PRELIMINARY DRAINAGE REPORT

Worldmark by Wyndham

Stormwater Review By:
Mohammad Rahman, PE, PH, CFM
Phone 480-312-2563 Fax 480-312-7781
e-mail: mrahman@scottsdaleaz.gov
Review Cycle #2 Date 1/31/18

Comments on Grading and Drainage (Cycle #2)
WORLD MARK BY WYNDHAM
(City of Scottsdale Case Number: 44-DR-2017)

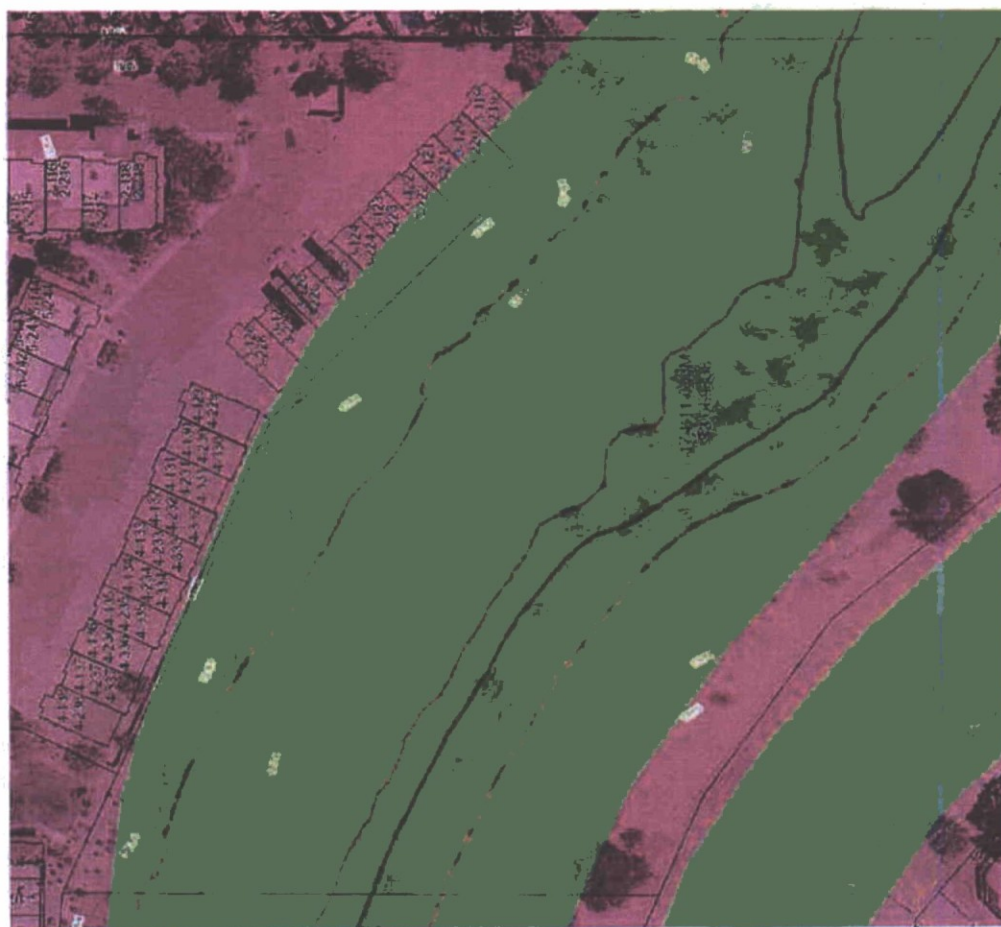
2. As can be seen in the below snapshot which is from the City's LIS (Land Information System), a number of rooms of the East Building is located in the FEMA unnumbered 'A' flood zone. The FEMA requirements for this site were discussed with Ashley Couch, PE, the City's Floodplain Administrator and the FEMA related review comments are based on his recommendations. A BFE (Base Flood Elevation) must be established for the each building.
[Reference: COS Stormwater Ordinance: Chapter 37] – **Not addressed. A BFE has not been established for either of the two buildings. The LF_{ss} of the two proposed buildings must meet the current FEMA requirements as well as the current COS Stormwater Ordinance and not what may have been approved in an outdated master plan.**

The Engineer has called out a 100-year HWE of 1280.83 in the channel on the 24"X36" Preliminary Grading Plan. However, the reviewer couldn't find this 100-year HWE on any of the supporting documents included in the report. Please clarify in Section 5 of the drainage report regarding this 100-year HWE elevation.

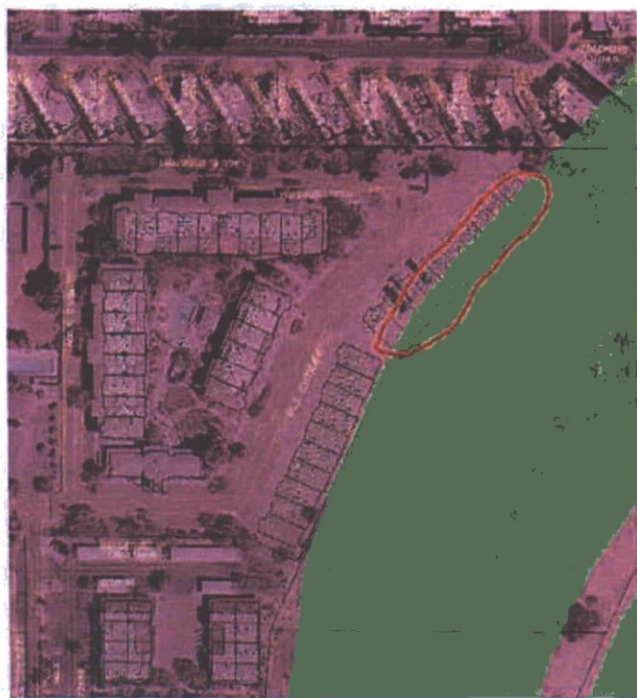
Also, citing the COS quarter section topographic maps (which date back to 2005) as the basis of establishing the LF_{ss} of the two proposed buildings is not acceptable to the City. As can be seen in the subsequent snapshot from the City's LIS which shows the 2010 FCDMC 2.0 feet contours and which are based on the flown LiDAR data for the Lower Indian Bend Wash ADMS, the north bank of the canal (along the narrow X zone 'strip') can be as high as 1283.5 feet which may be the defining elevation for the BFE. However, the LiDAR data is not acceptable for design purposes due to its potential elevation errors.
